Woodbank House, Balloch Inspection Report

v01. 08/06/2017

Barham Glen Architects Ltd

South-east corner and remains of south gable.

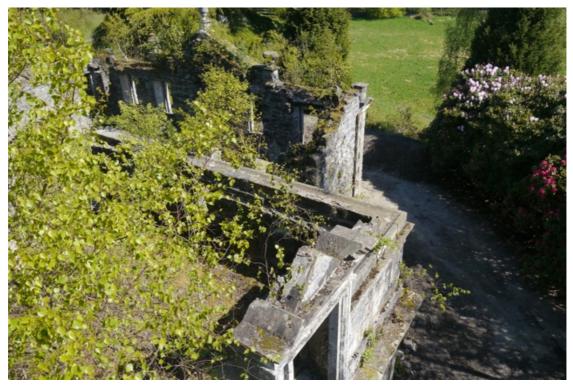
Old photographs show a steep roof to the original house, with high gables. What remains of this wall contains little of architectural value, including patch repairs in a variety of materials, including brick, block and cement mortar.

Nevertheless, there will be many strong reasons for rebuilding this wall in its original position, if not for its full height. These include:

(a) providing lateral stability to a retained and repaired main elevation;

(b) maintaining the architectonic link between the two main elements of the the structure, the east and south façades.

Above - vegetation growing off concrete second floor behind west gable. Left - open mortar joints to west gable.

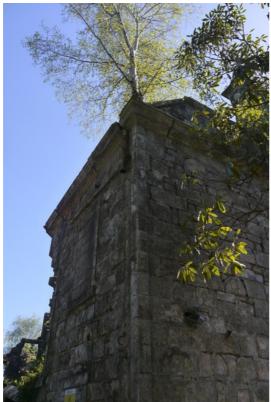
While this wall is less visible there are two reasons why it should be retained and the defective upper section rebuilt:

(a) providing lateral stability to a retained and repaired main elevation;

(b) the armorial plaque at second floor level is referenced in the building's listing.

The present positioning of the plaque would also point to the reconstruction of the gable chimney, which would also help give definition to the end of the building. Alternatively there may be scope for relocating the plaque elsewhere on the building, if this were acceptable to the planning authorities.

The gable wall is built of squared and coursed sandstone however it is difficult to tell whether it was originally pointed or rendered.
